**Response to s165 Conditions of Notice of Decisions for Application ID: 201936510**

**Project Name: Proposed Asphalt Plant, Hume – Independent Expert Review 2**  
**Reference: 21.1004.L1V1**

<b>Project Name:</b>	<b>Proposed Asphalt Plant, Hume – Independent Expert Review</b>
<b>Reference:</b>	<b>21.1004.FR1V1</b>

**Proposed Asphalt Plant, HUME  
5 Paspaley Street (Block 67 Section 22)**

**Figure 2-3: Odour dispersion modelling results for the 99.9<sup>th</sup> percentile 3-minute average (ERM, 2020)**

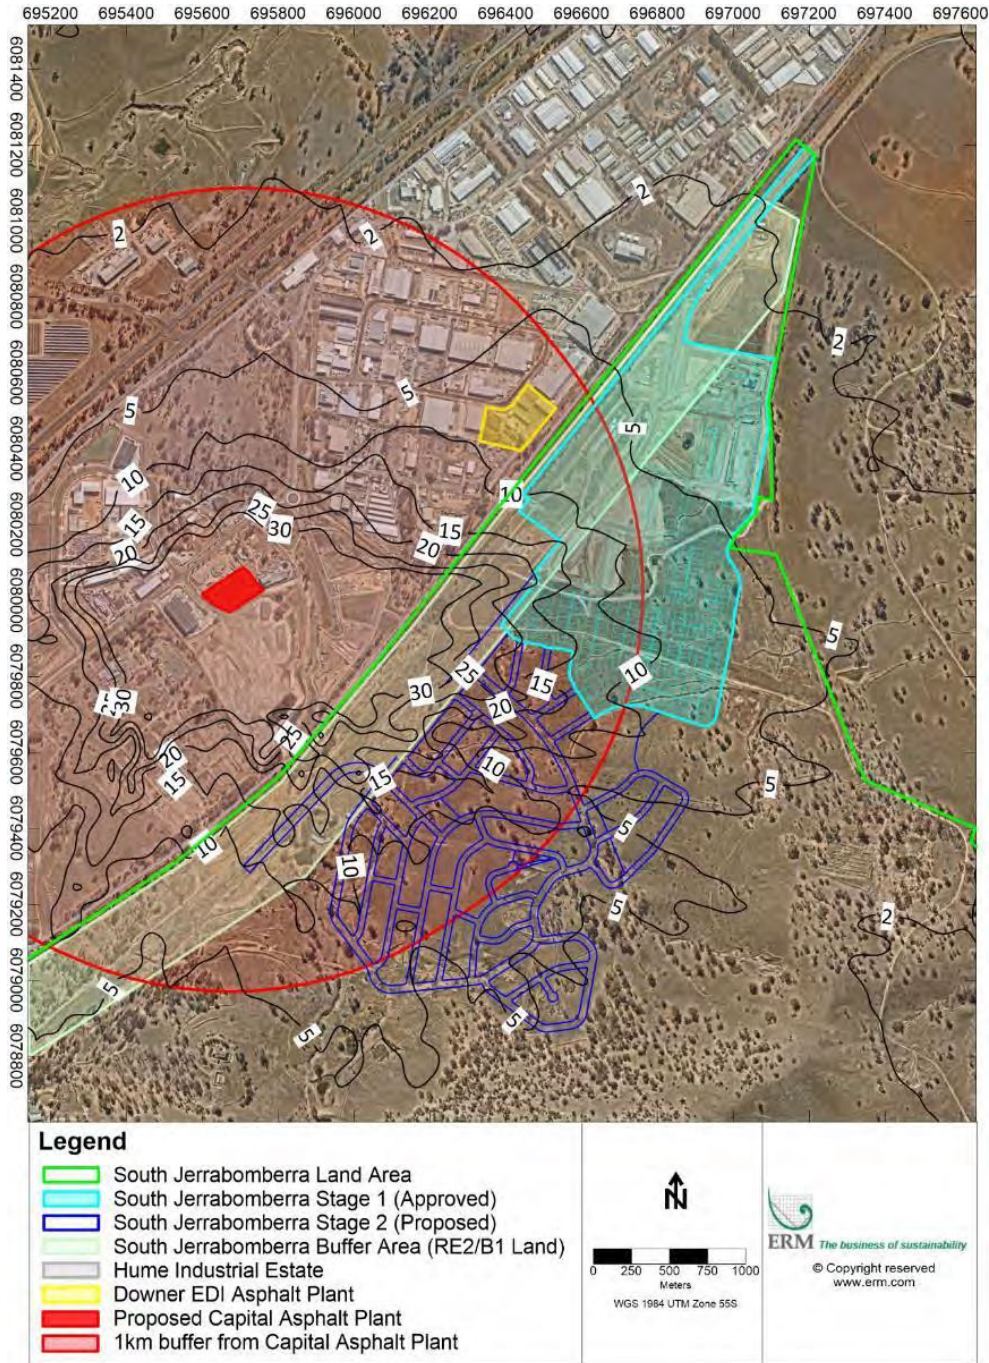
The ERM submission letter additionally provided equivalent modelling of the 99.9<sup>th</sup> percentile, 3-minute odour predictions, which are shown in Figure 2-3.

At the closest South Jerrabomberra receptor point (approximately 600m southeast) the odour concentration predictions made within (ERM, 2020) are approximately 30 OU.

**Figure 2-4: Annual and seasonal windroses for Capital AQIA CALMET extract (2018)**

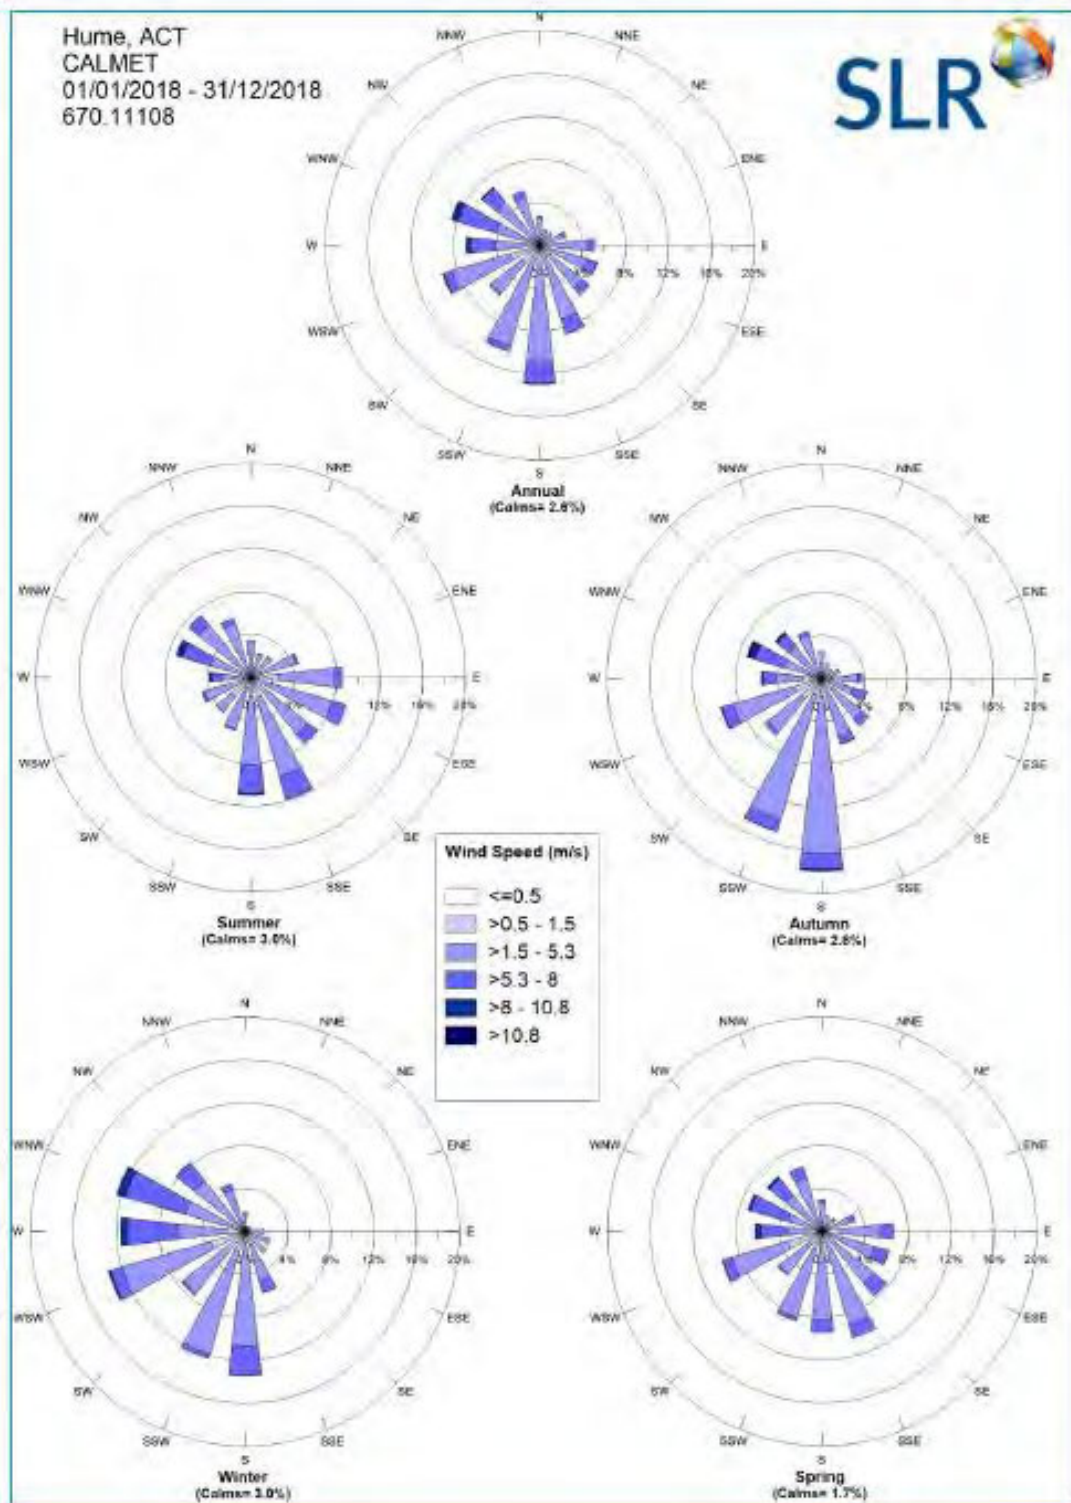
Based on the Tuggeranong and Canberra Airport wind roses, this would be approximately 30% of the time. By comparison, the annual wind rose produced by CALMET in the Capital AQIA (Figure 2-4) appears to estimate northwesterly winds around 20% of the time.

*Recommendation 5: The simulation of local meteorological conditions should be reviewed so that they can be demonstrated to be representative of the Hume and South Jerrabomberra area.*
